STATE OF HAWAII
DEPARTMENT OF TRANSPORTATION
HIGHWAYS DIVISION

INTERSTATE ROUTE H-1
Kunia Interchange Improvements
F. A. I. Project No. 1M-HI-1(219)

SHEET No. L48 OF 52 SHEETS

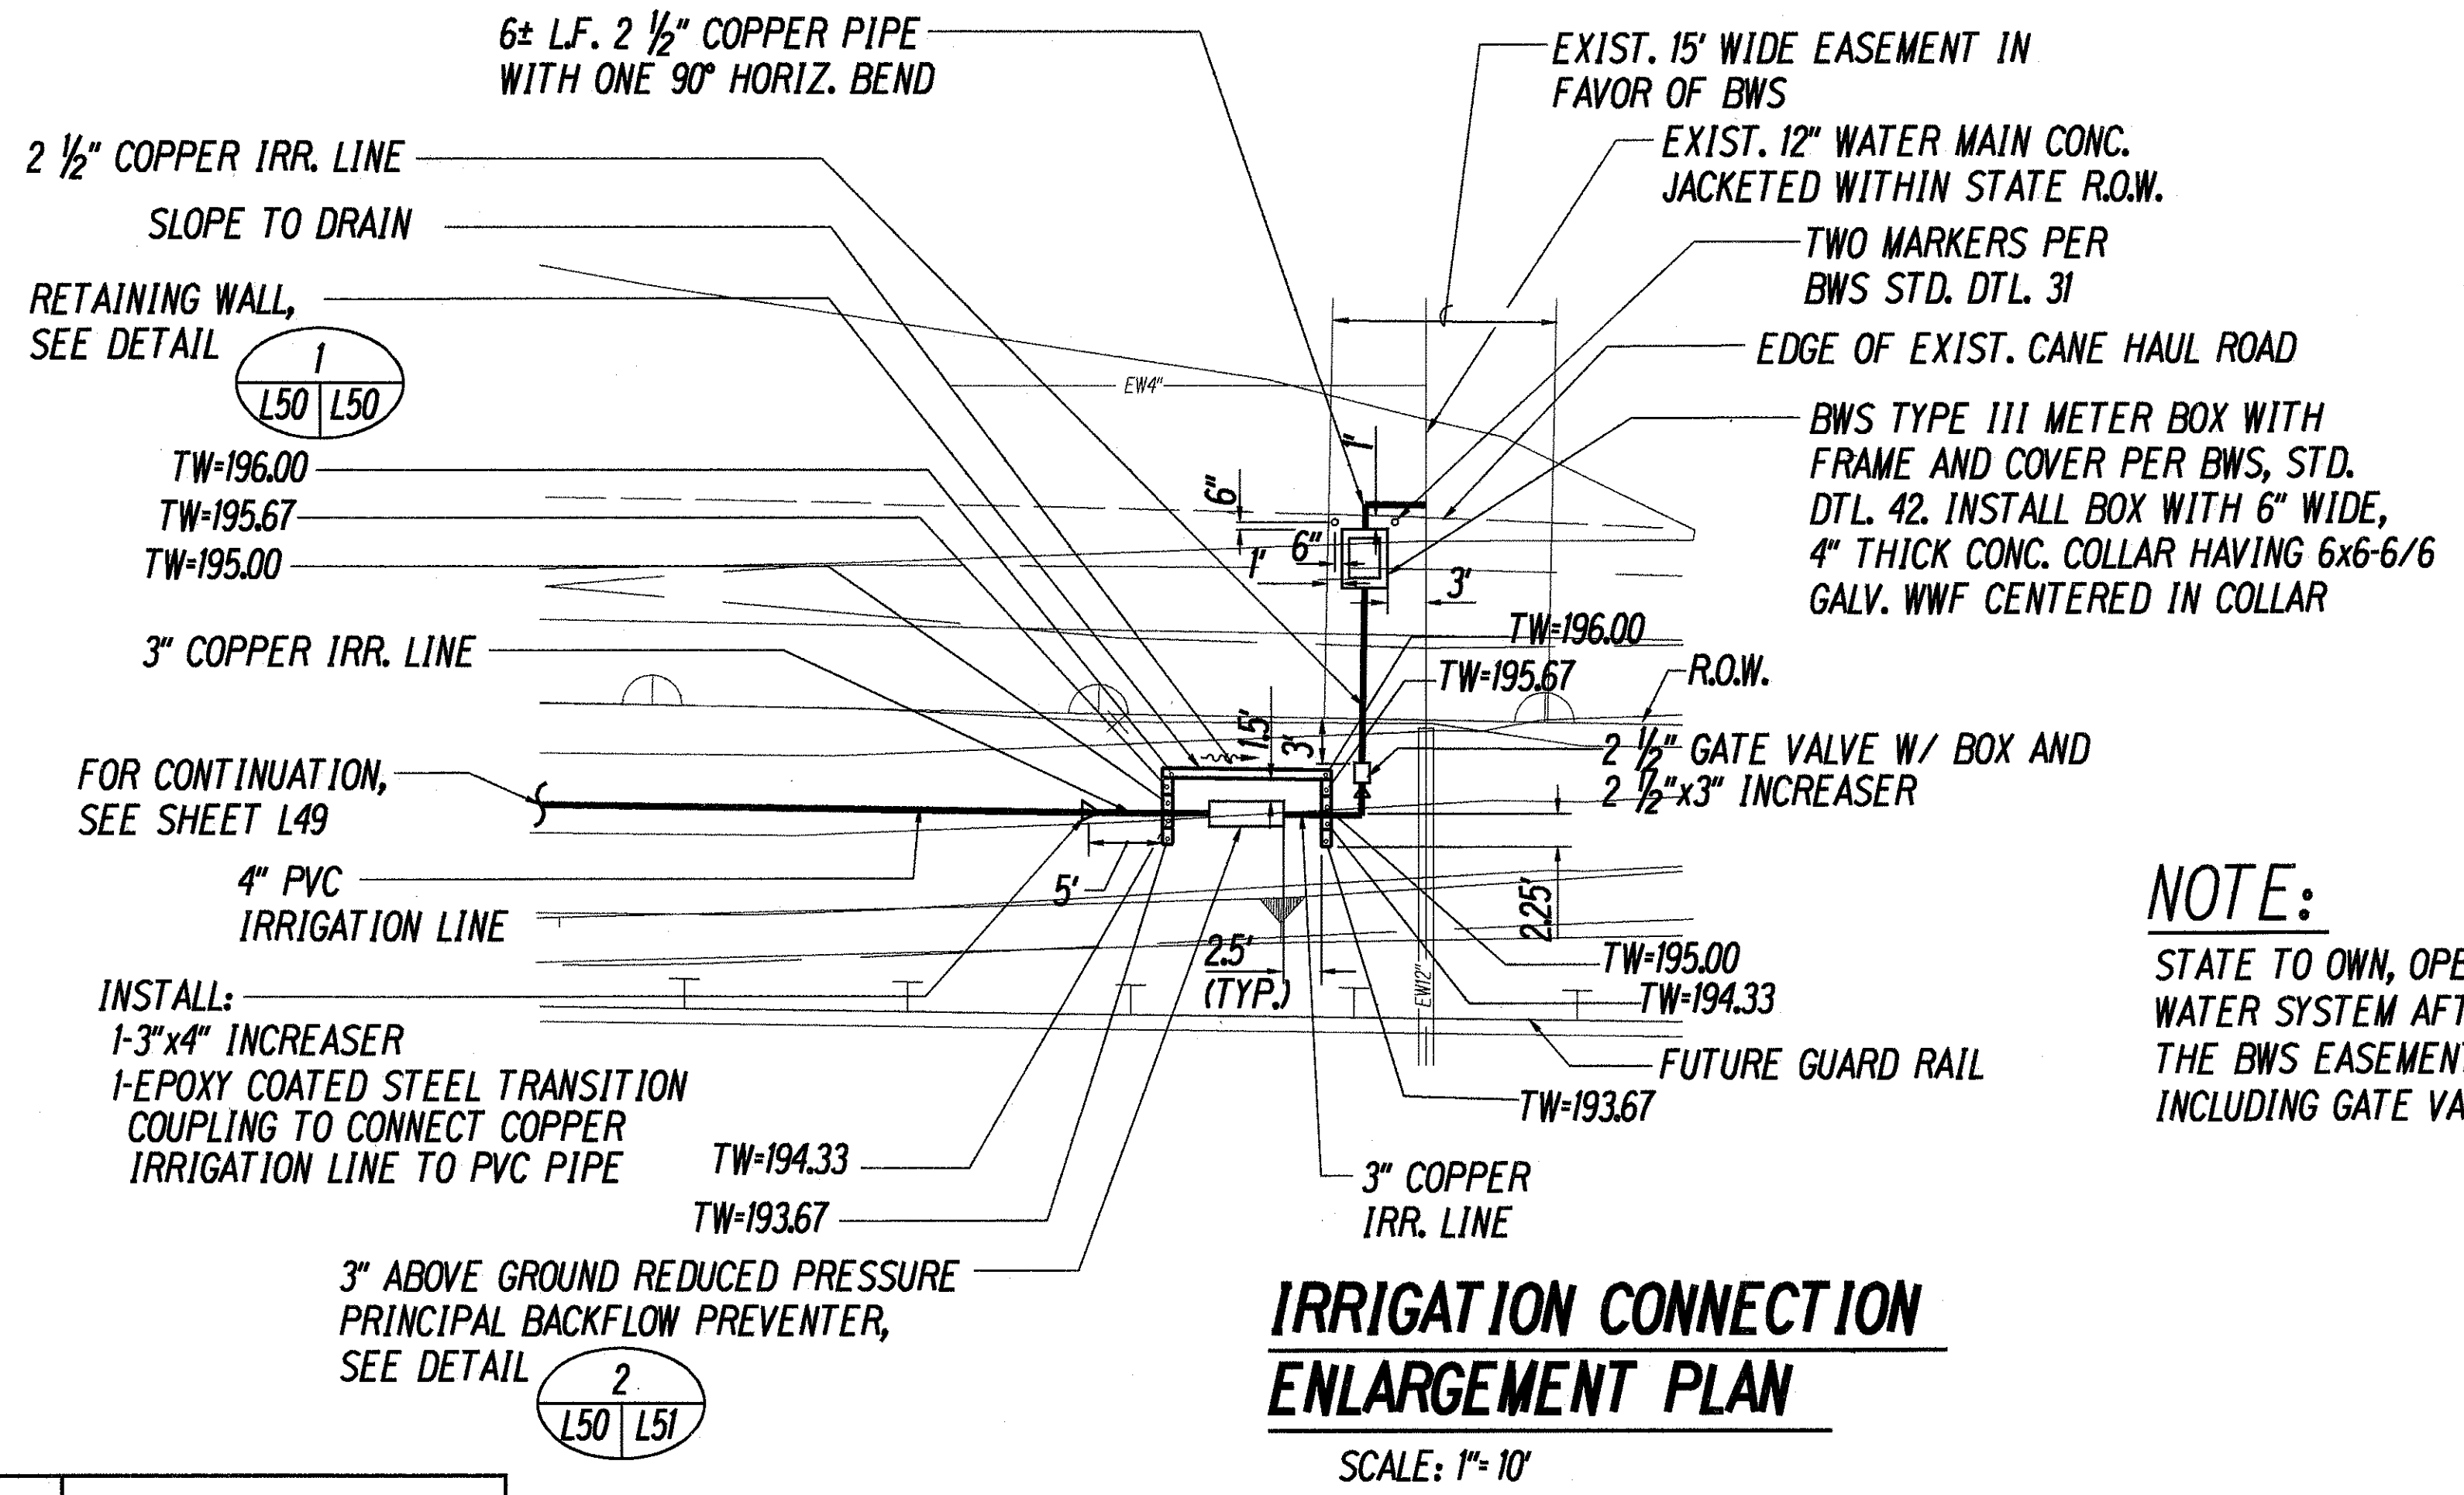
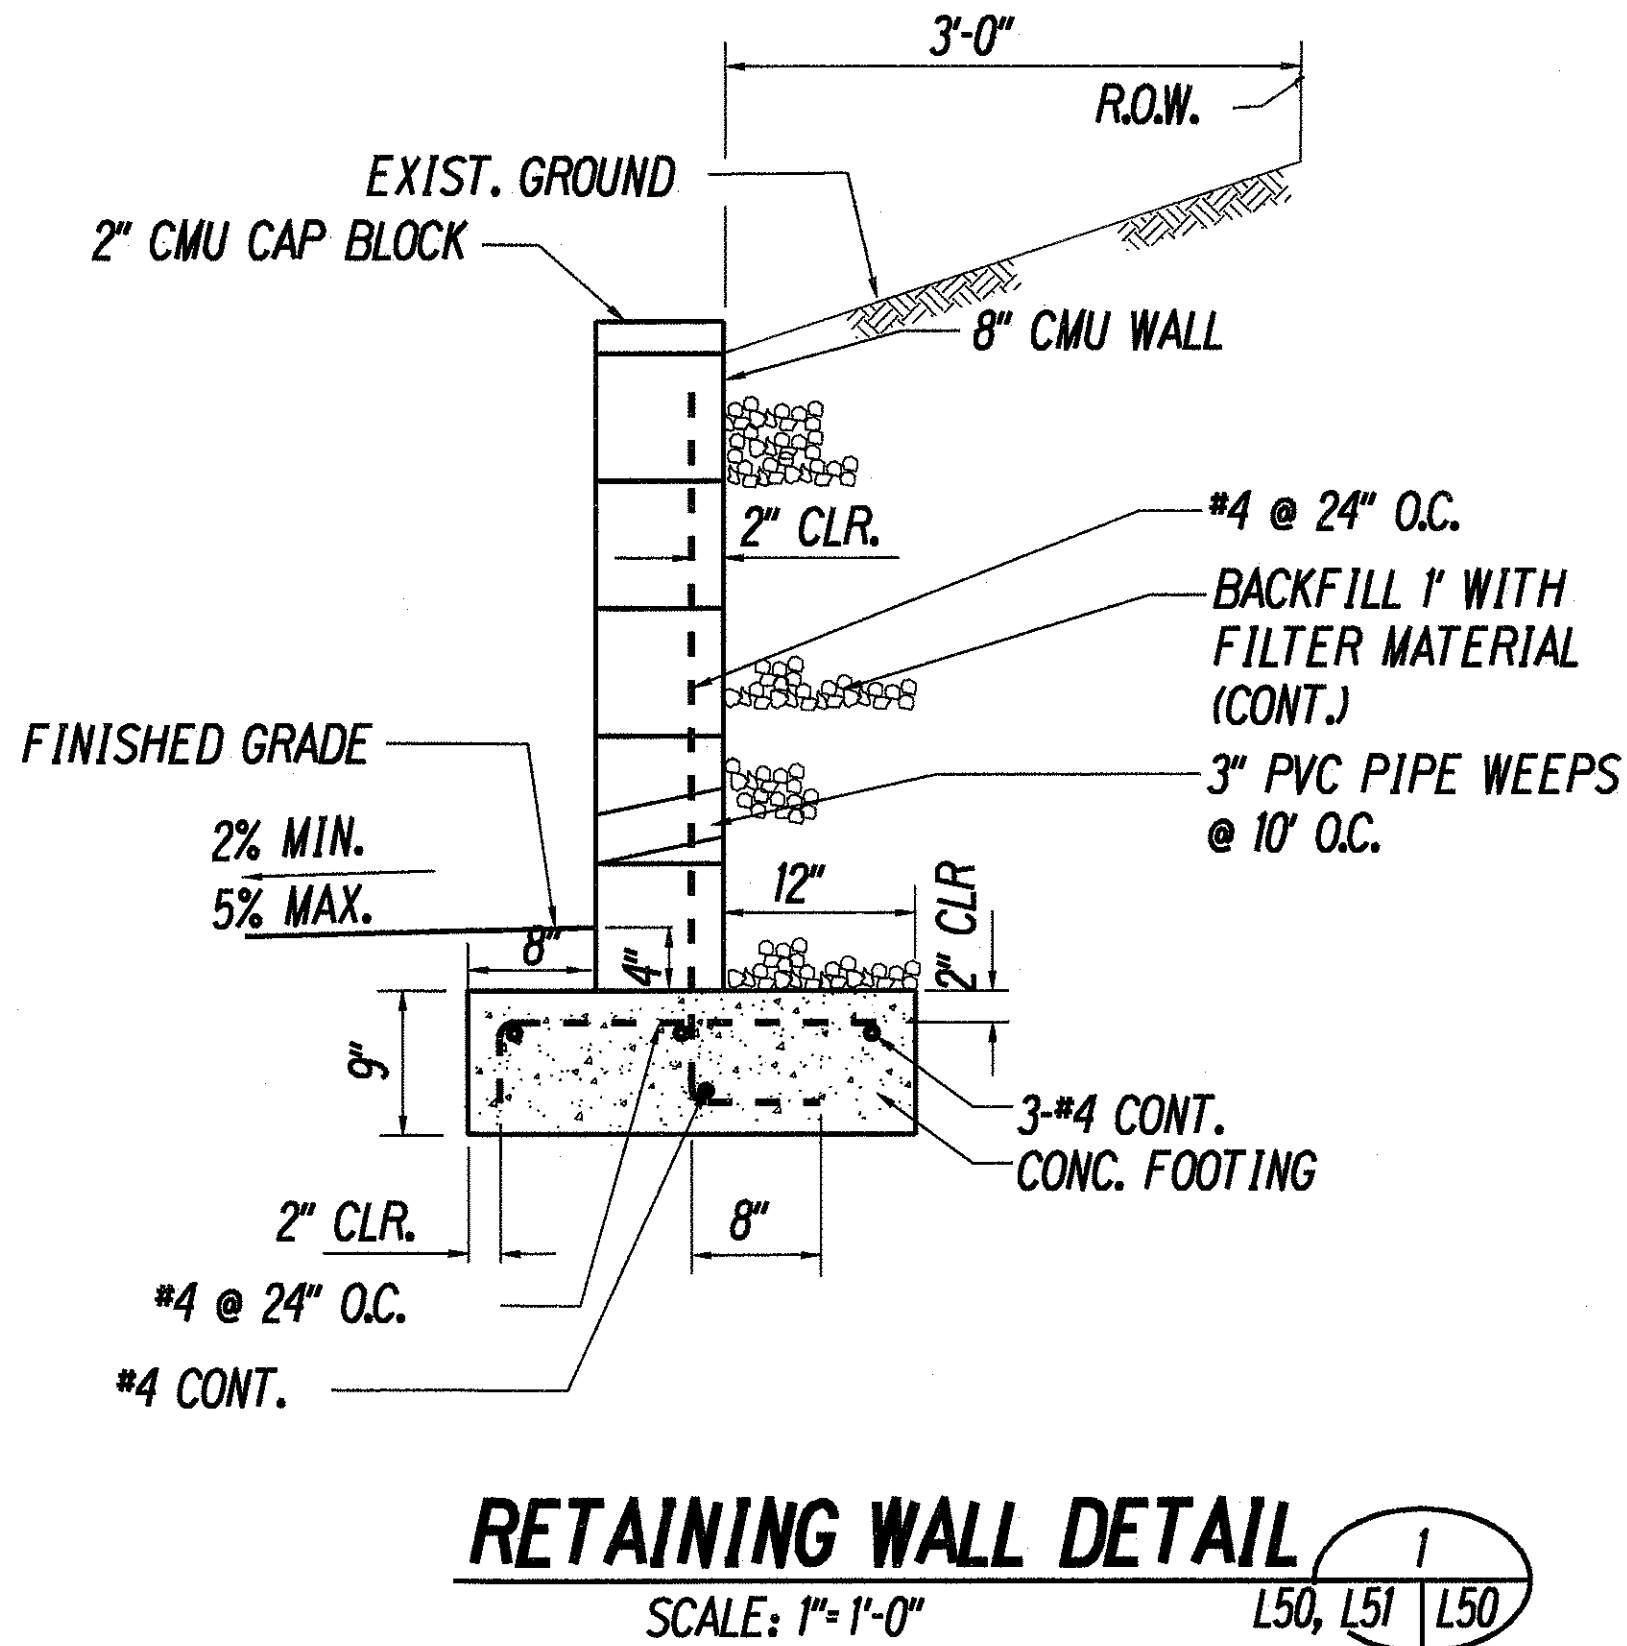
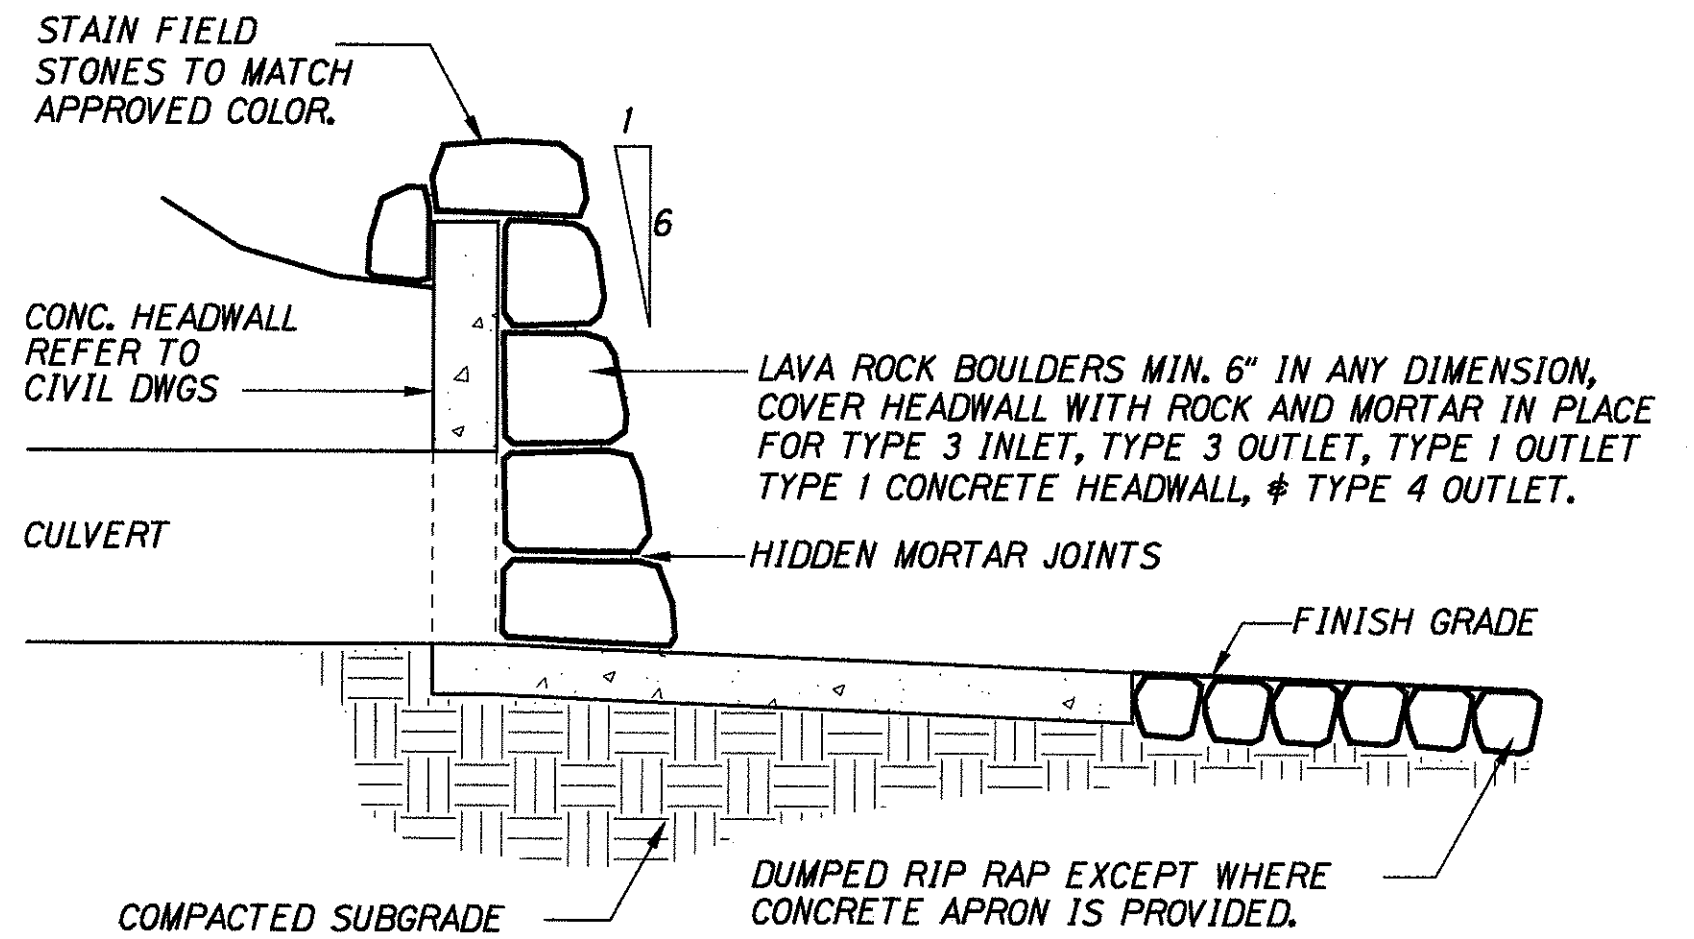
8/17/98	Revised Sheet to add Detail No. 8
4/3/98	Revised Detail No. 7 Per Addendum No. 3.
DATE	REVISION
